Item 3.**Section 4.55(2) Application: 410 Pitt Street, Haymarket - D/2020/1387/C****File Number:** D/2020/1387/C**Summary**

The 'subject' Section 4.55(2) application (D/2020/1387/C) seeks consent to amend the development consent relating to the 'Stage 2' detailed design.

Figure 3: Left: north elevation plan extract, as lodged with the subject application Right: as amended during assessment. A proposed acoustic screen has been deleted (red arrow).

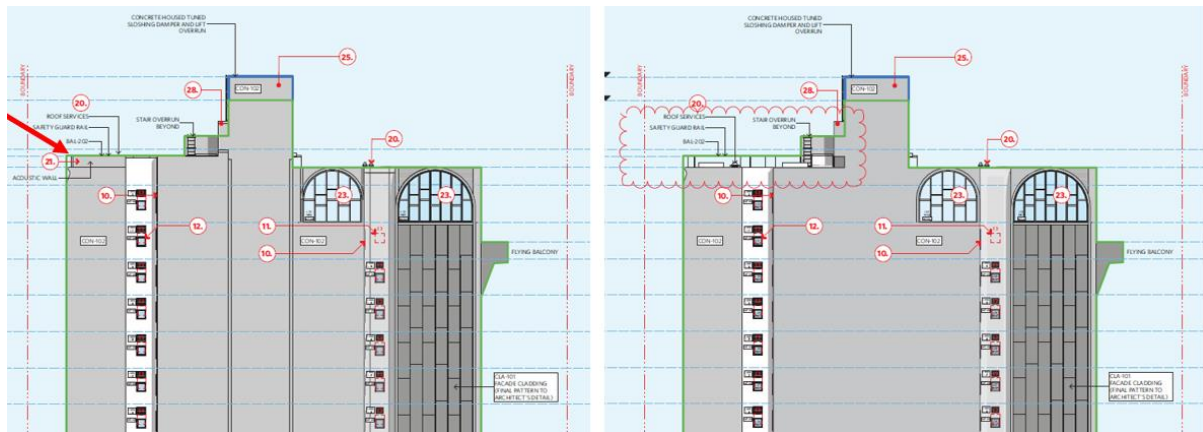
- 12. The applicant amended the proposal during assessment, in response to issues raised by Council's officers. The amendments reduce the scale and impacts of the proposal as compared to lodgement and were not re-notified to neighbouring properties.
- 13. Amendments provided during assessment address the following issues:
 - (a) Building height and impacts on views across the site:
 - (i) a proposed acoustic screen has been deleted, maintaining views across the site from neighbouring residential apartments (Figures 3 and 4 below);
 - (b) Ventilation grills on the boundary:
 - a statement has been provided justifying the location of louvres. Notwithstanding this, the louvres are not supported. See Discussion section below.
 - (c) Operable windows:

- (i) operable windows are shown on the western elevation but not the eastern elevation as originally approved. A condition is recommended to address this issue. See Discussion section below; and
- (d) Street awning:
 - (i) drawings have been amended to show the street awning having two supports at the west elevation, in line with previously approved documents including the public art plan.

32. The application has been amended during assessment to delete a proposed acoustic screen from the northern elevation of the roof level (see Figures 3 and 4 and the 'Amendments' section above). Notwithstanding this, the proposal involves increasing the height of the approved lift overrun and sloshing damper by an additional 1.99m.

- (a) *The note describing 'acoustic wall' on the north elevation numbered A-SA-210-001 must be deleted noting there is no approval for any acoustic walling.*

- (a) although the acoustic screen has been deleted from drawings, it is necessary to remove a note on the north elevation plan, describing an 'acoustic wall';

Figure 21: Materials and Finishes Schedule

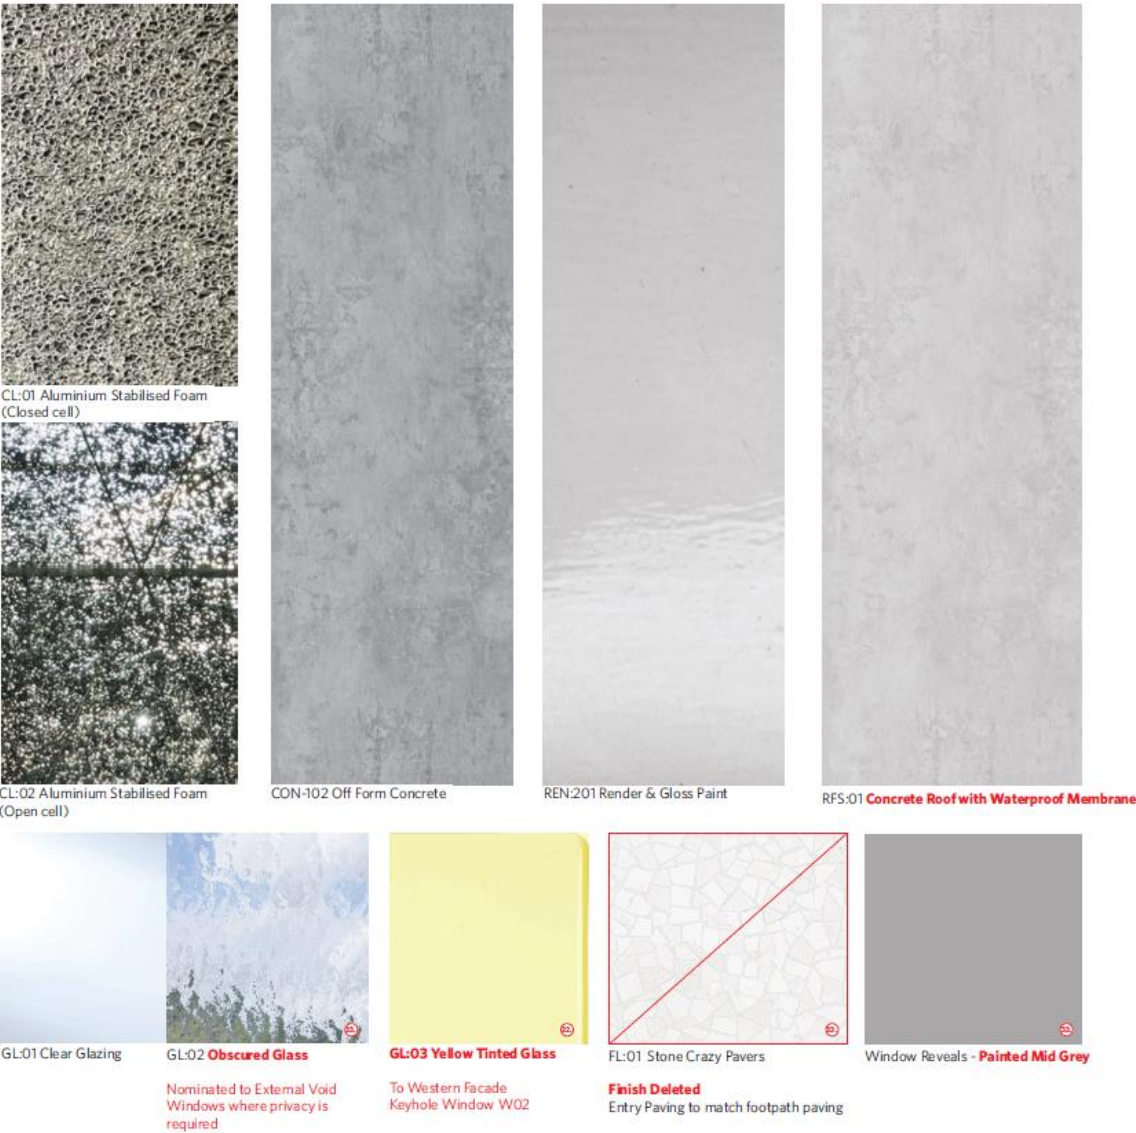
- (e) with regard for maintaining high quality materials and to ensure visual privacy is addressed:
 - (i) Material 'RFS:01': the proposal to change the previously approved zinc roof to a concrete roof is not approved; and

- (ii) Material 'GL:02': Obscure Glass is to be provided to all corridor windows facing north and level 31 T-05 Duplex north facing window. These are to be noted in both plan and elevation.

- (d) *Details of privacy treatments to the east facing rooms are to be provided. These are to be noted on amended plan and elevation drawings.*
- (e) *Material RFS:01 Concrete roof with waterproof membrane is not approved on the Materials & Finishes Schedule A-DA-730-001. RFS:01 is to be amended to be a Zinc Roof consistent with the previously approved Materials and Finishes Schedule for D/2020/1387/A. This amendment is to be captured in an amended Materials & Finishes Schedule, in plan and elevations.*

- (f) *Material GL:02 Obscure Glass is to be provided to all corridor windows facing north and level 31 T-05 Duplex north facing window. These are to be noted in both plan and elevation.*

Figure 24: Level 37, Uni 263 (View 1) - additional view impacts are limited to 'views of the sky' that are already affected by previously approved development on the site

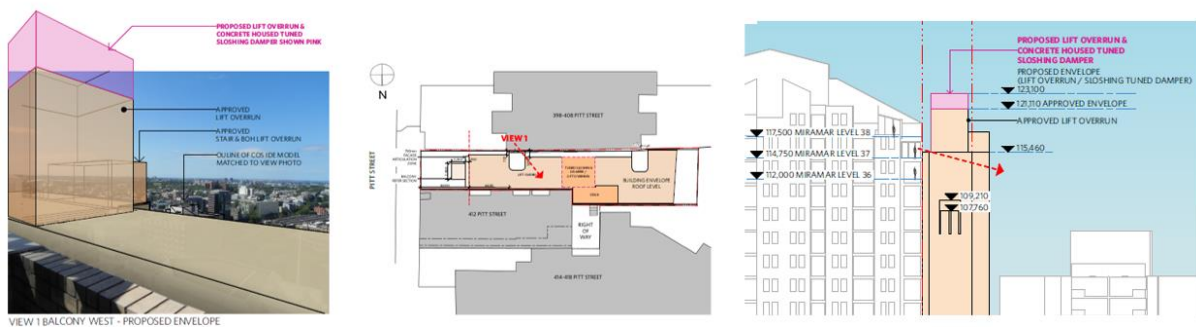
37. The view studies lodged with the application demonstrate the proposed increases to the approved height of the lift overrun and sloshing damper will not have any significant additional view loss impacts for residential apartments located within the neighbouring building at 398-408 Pitt Street. The proposal is satisfactory when compared to the four-step assessment recommended by Senior Commissioner Roseth in the planning principle pertaining to views.

Figure 28: east elevation plan extract, showing all works increasing the height of the building to be below the Belmore Park sun access plane

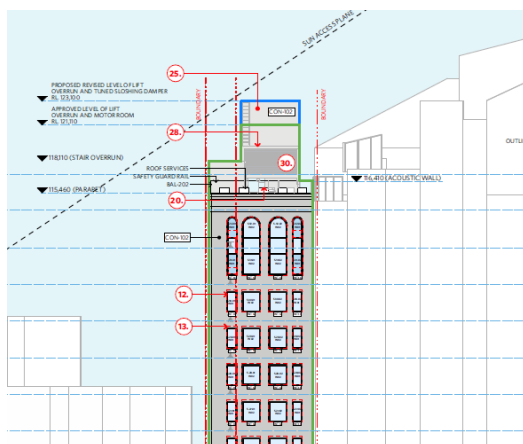
38. The applicant has provided details in relation to the proposed increase to the existing building, confirming it will comply with the relevant height standards, established by the sun access planes for Belmore Park.
39. The application was referred to the City's Modellers, who confirmed the proposed modifications comply with the recently updated sun access planes for Belmore Park (as well as the superceded sun access planes).
